ORDINARY COUNCIL MEETING

Tuesday, 11 June 2024

Planning Authority Report

| Description | The applicant seeks planning permission for the use and development of multiple dwellings (10 Units) and demolition of outbuildings. <i>Documents submitted by the Applicant are attached, titled Application Documents.</i> |

12.1.3 Representation 2 - Hall

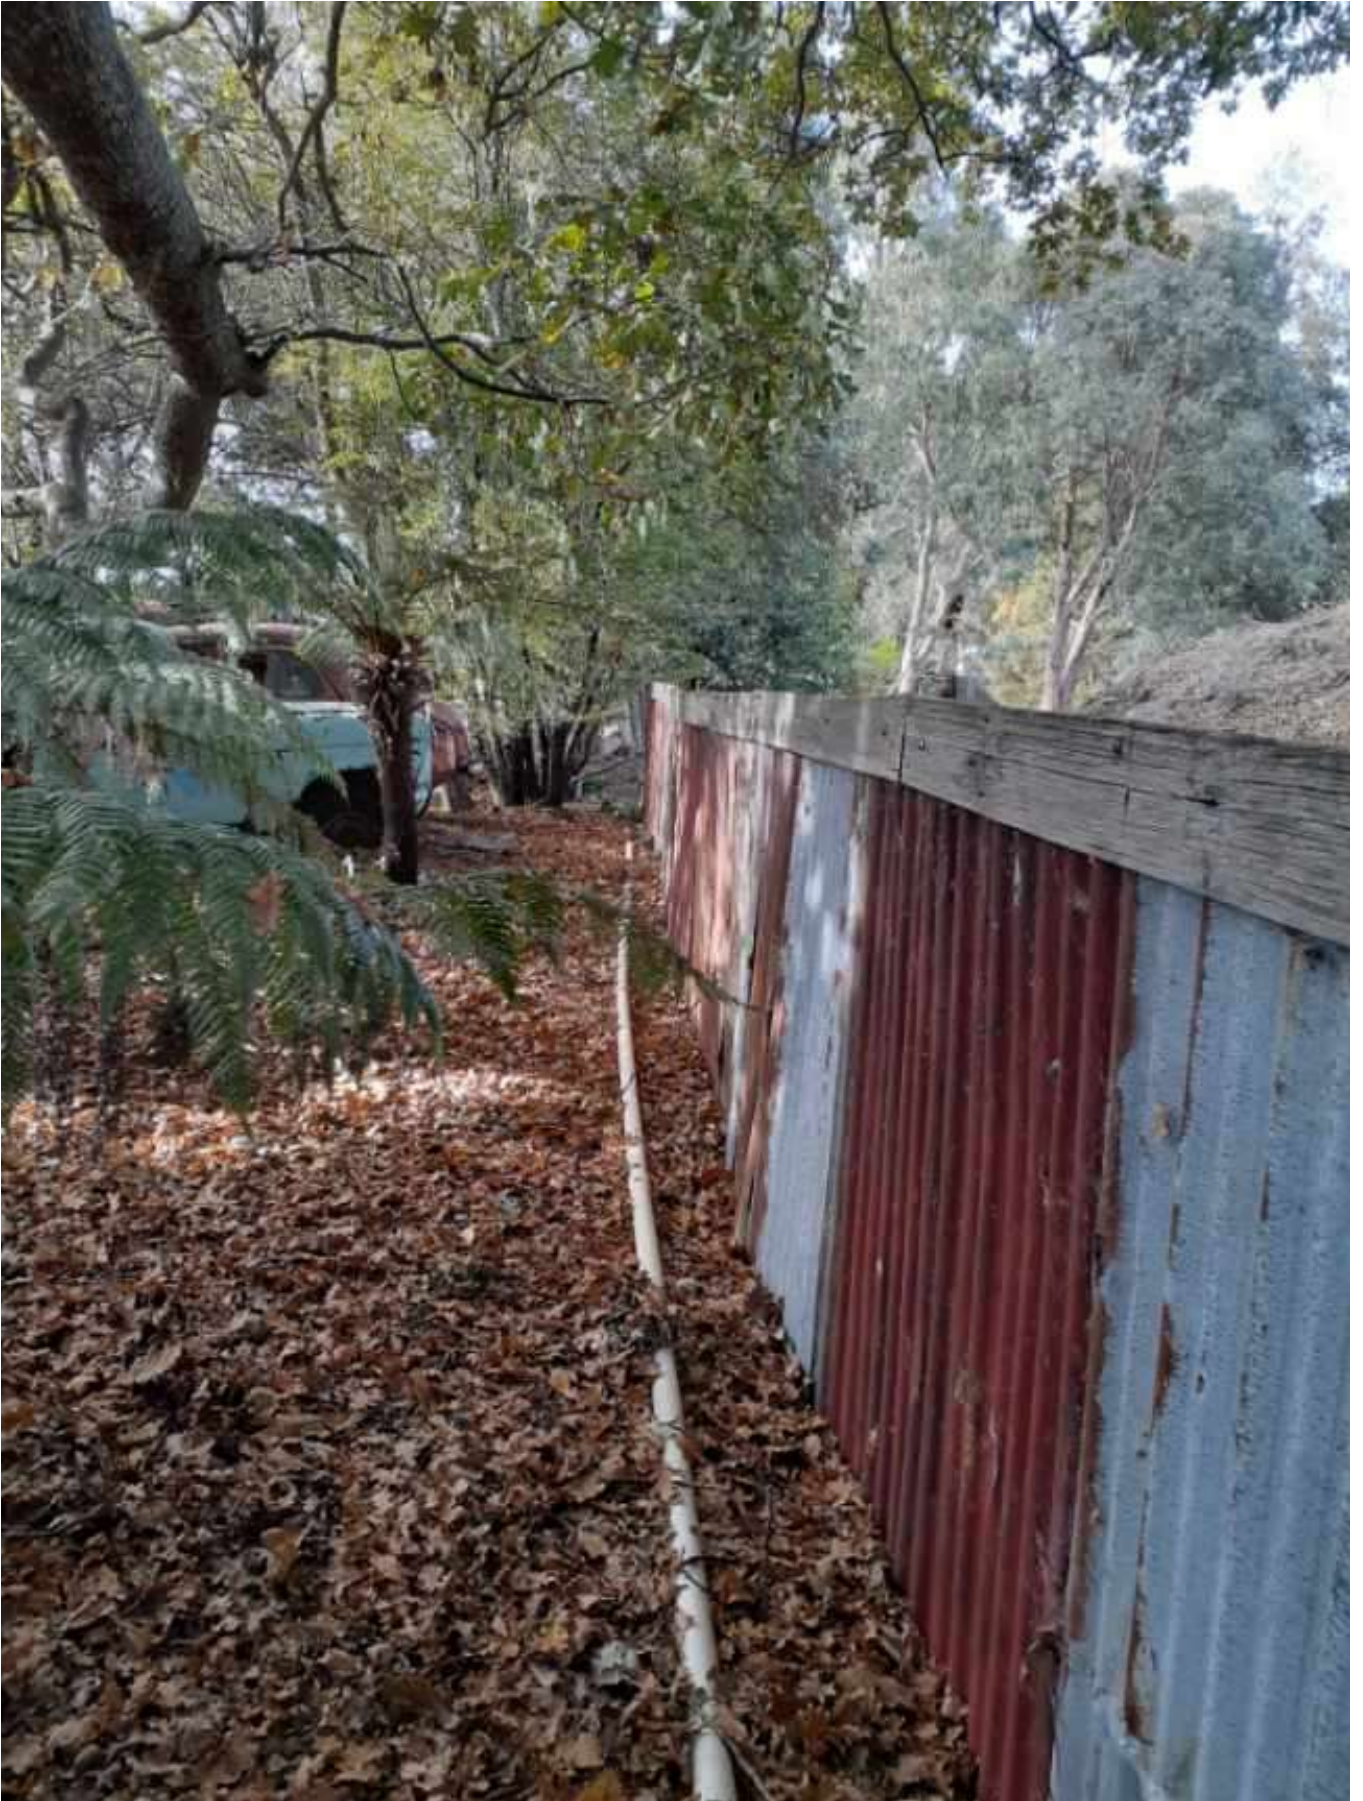
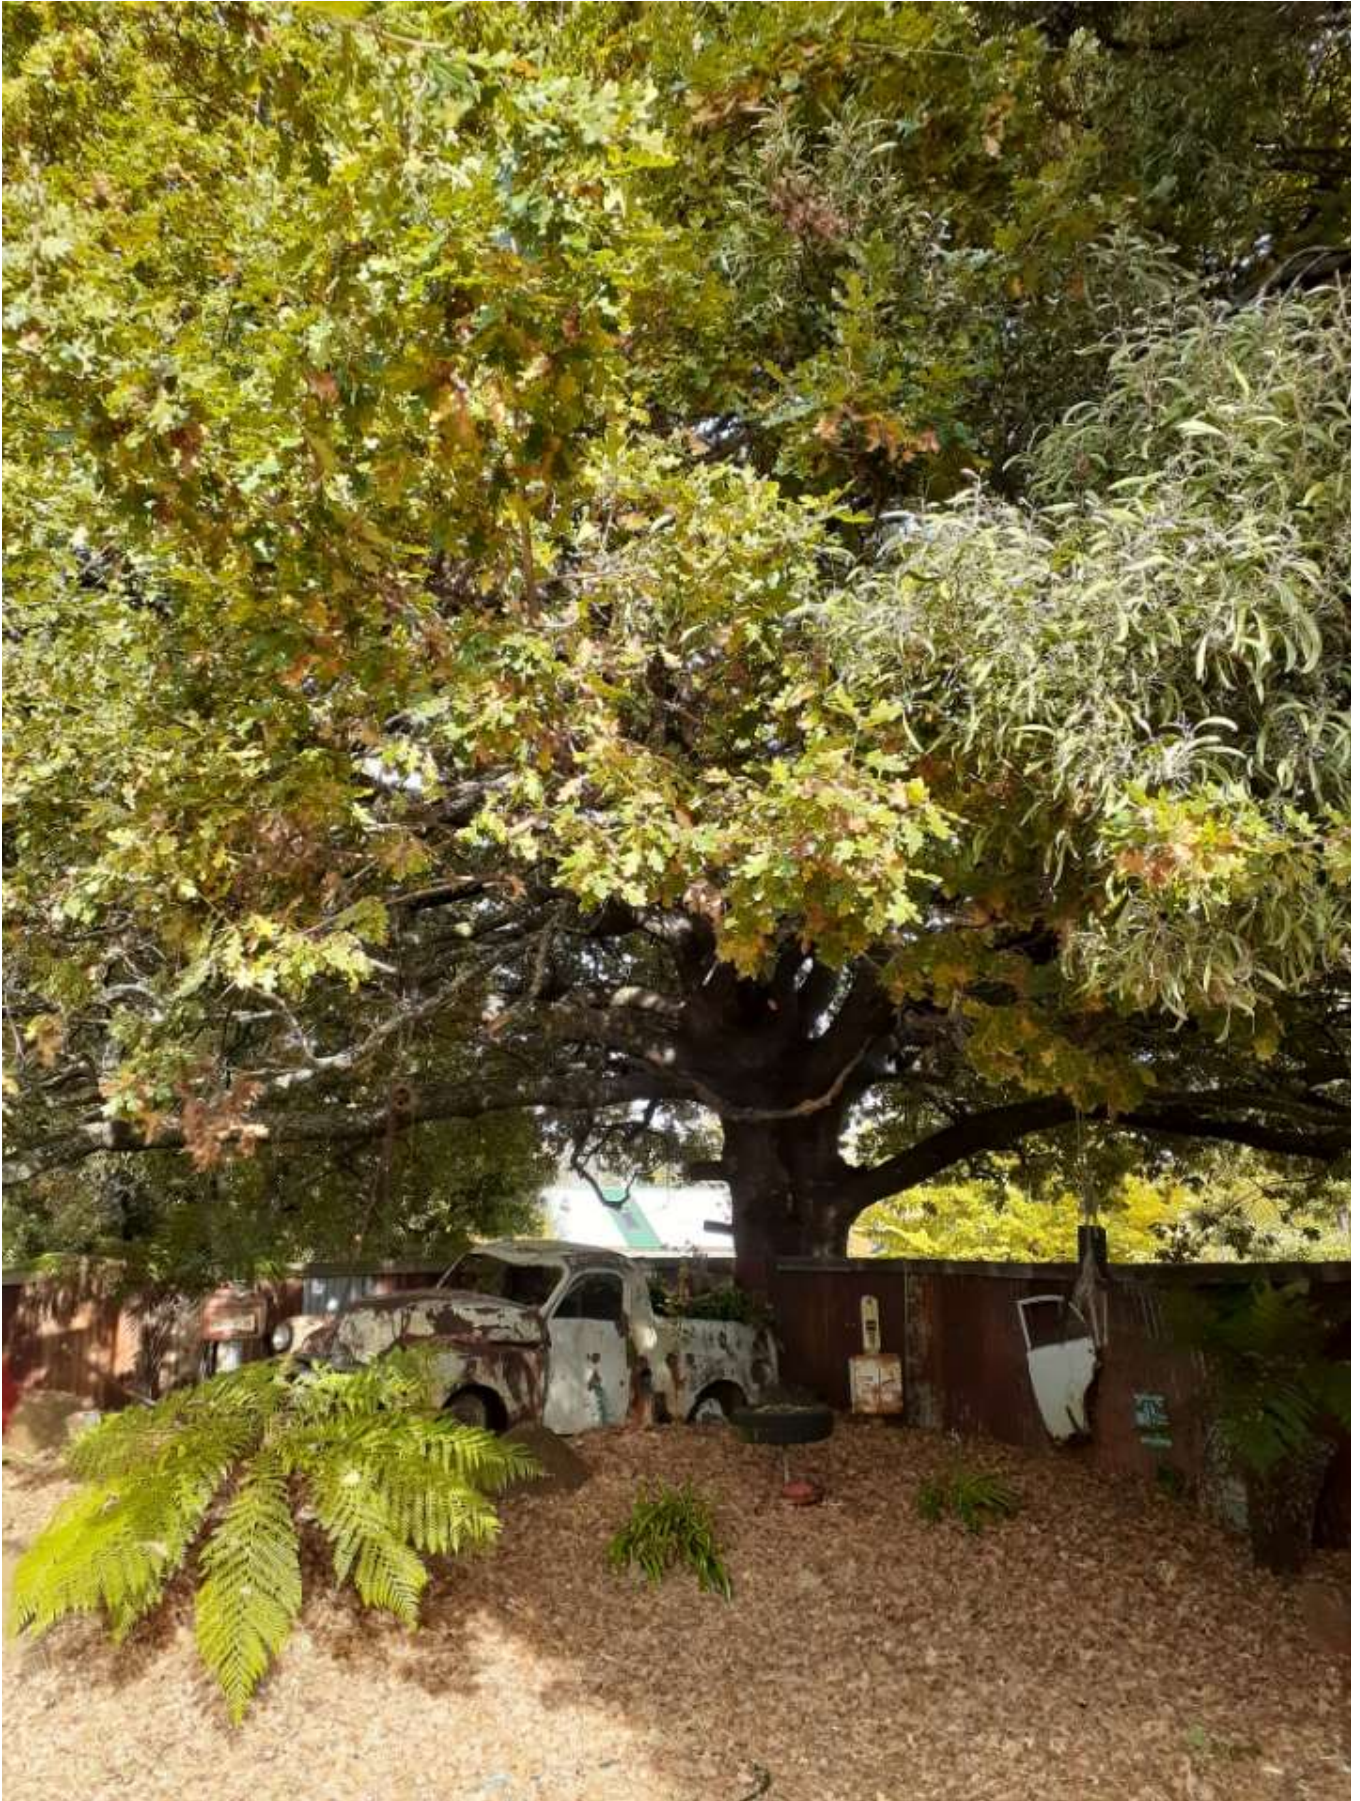
- It appears from the plans that the existing pipe will need to be upgraded to a larger pipe?
- If this is correct, and a larger pipe is to be installed will excavation occur on our property in our landscaped area?
- Will the developer be responsible physically and financially to replace our landscaping to its current condition?
- Will there be an undertaking that the large oak tree and it's roots will not be damaged?

- According to the submitted plan a proposed stormwater main is to be installed for some distance on 111a Meander Valley Road to deal with some of the stormwater. We cannot see why the proposed stormwater main to be installed could not continue down this boundary on 111a Meander Valley Road and then connect into the connection at 12 Quamby Street, Westbury. This would save entering our property and digging up our landscaping.

Any planning permit must ensure the stormwater network downstream of the stormwater connection has sufficient capacity. In this regard a series of conditions have been recommended to be included on any
